**Magnet/Syringe Separation Issues**  
**V.B. Graves**  
**8/16/05**

This document is an initial response to the results of Peter's analysis on the attractive forces between the magnet and the steel hydraulic cylinders in the baseline syringe pump design.

**Fig. 1. Existing Design**

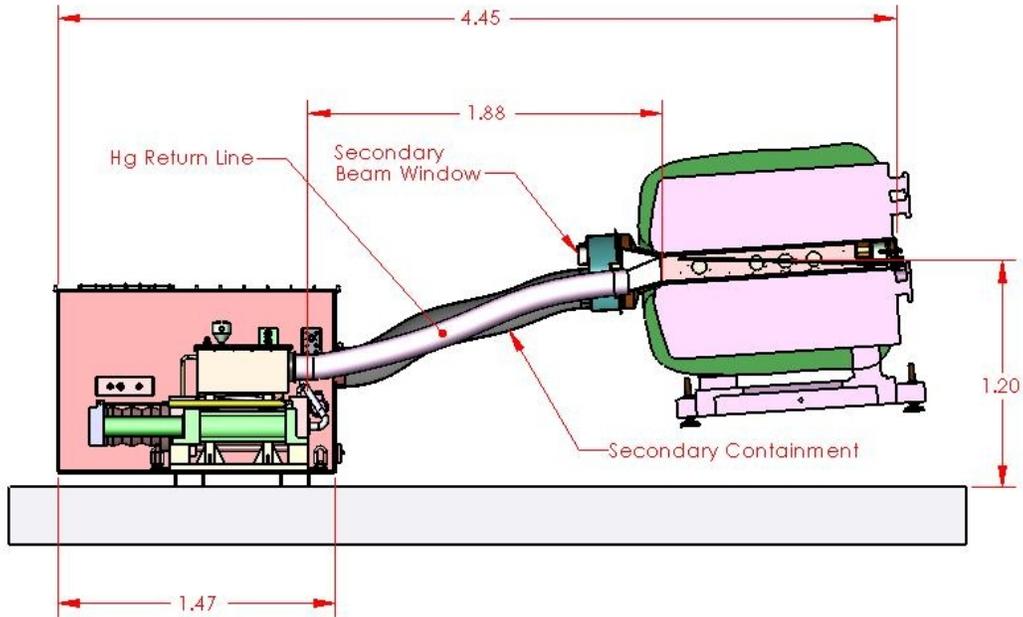
To minimize changes to the current design (Fig. 1) this separation would most easily be accomplished by increasing the length of the flexible hoses between the sump tank and the target module, keeping the sump tank and cylinders inside a secondary container box. The secondary bellows surrounding the Hg supply and return lines would necessarily lengthen as required. Conceptually this is shown in Fig. 2. This change has several implications on the design, some positive in nature and some negative. I have listed some of these below, but I'm sure that more will develop as the redesign progresses. *Those issues that deal with the cylinders must be resolved prior to the syringe pump procurement.*

**Fig 2. Separated System Conceptual Layout. Intermediate hose supports not shown. Dimensions in meters.**

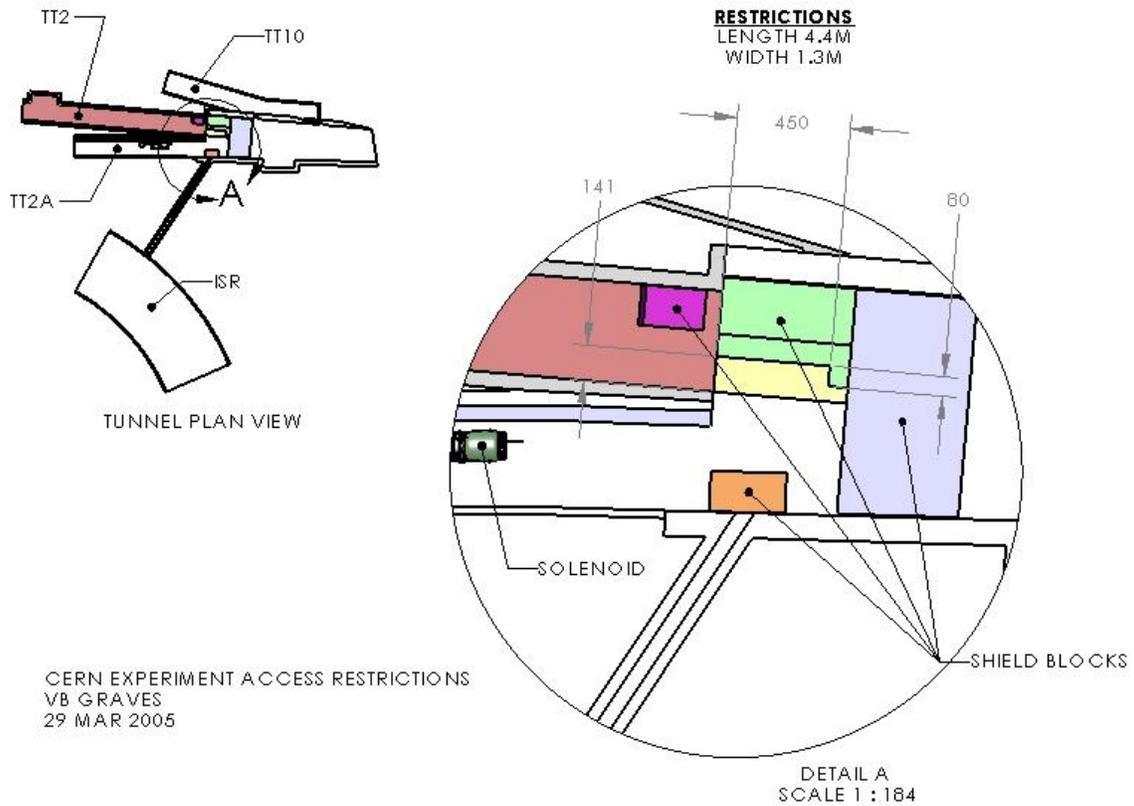
- The common baseplate cannot be extended 2m in length due to the fixed beam elevation and facility constraints both at MIT and CERN. This implies that a common baseplate is not needed. However, it is still required that the magnet be elevated, tilted, and aligned with the beam, so some sort of magnet baseplate will be necessary. Because it already incorporates a means to perform alignment adjustments, one option would be to shorten the current baseplate so that it only supports the magnet.

- With flexible hoses, the syringe does not have to be tilted and may sit directly on the floor (or a mobile baseplate).
- The syringe system no longer has to be directly in line with the magnet or beam, which would allow some flexibility in positioning. This may be beneficial during integrated tests at MIT.

- With 1.5m – 2m of flex hose, the target module might be manually inserted into magnet, so syringe system does not require rolling cart. Estimated weight of the target module is 100-150 lbs.

- With no magnetic attraction forces to deal with, carbon steel cylinders, rods, and pistons can be used in the drive cylinders. The Hg cylinder will still be designed for water service (i.e., chrome plating cylinder walls, piston, rod)
- Because the syringe is no longer interfaced to the magnet through the common baseplate, minimizing the syringe length is no longer a driving requirement. The Hg cylinder diameter could decrease from 10" to 8", putting it in the "low-cost" family of cylinders. With an 8" Hg cylinder, maintaining the 12-sec jet requirement will increase the required stroke by 8" and the total extended length by approximately 13".

- Added flex hose will require support to prevent sag due to Hg weight.
- Flexible hoses have internal convolutions that will trap Hg in these slightly-sloped hoses and will have more flow resistance than rigid pipe. For flow reasons, it would be preferable to use rigid pipe for most of the new length with flex hoses on one or both ends. Use of 2m of rigid pipe makes it impractical to ship and transport assembled system (syringe, pipe, target module), so assembly and disassembly of the primary containment would be required at MIT and CERN. However, the use of rigid pipe is not absolutely required, and the desire to not open the primary containment in the MIT and CERN facilities probably overrides the flow issues.
- Additional length of pipe requires additional Hg inventory to pre-fill supply line prior to syringe actuation (2m of 1" pipe will require approx 1 additional liter).

**Fig. 4. Existing target module bracing method**

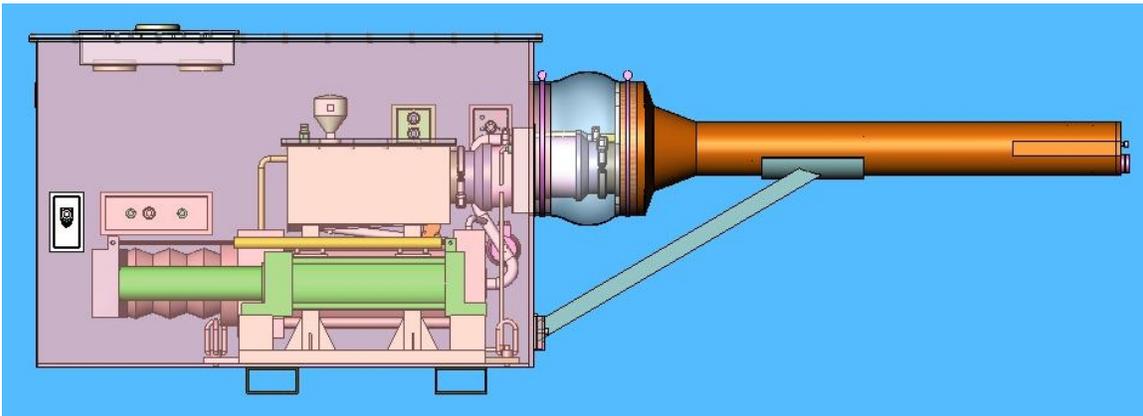
- Because the syringe pump & containment box would be positioned below the beam, the downstream secondary beam window would move to the target module rather than the secondary containment box.
- Downstream end of target module would require changes to accommodate different secondary containment.
- Supporting the target module off of the secondary containment box from 2m away is not practical (see Fig. 4). Secondary containment baseplate could have provisions for storage of target module.
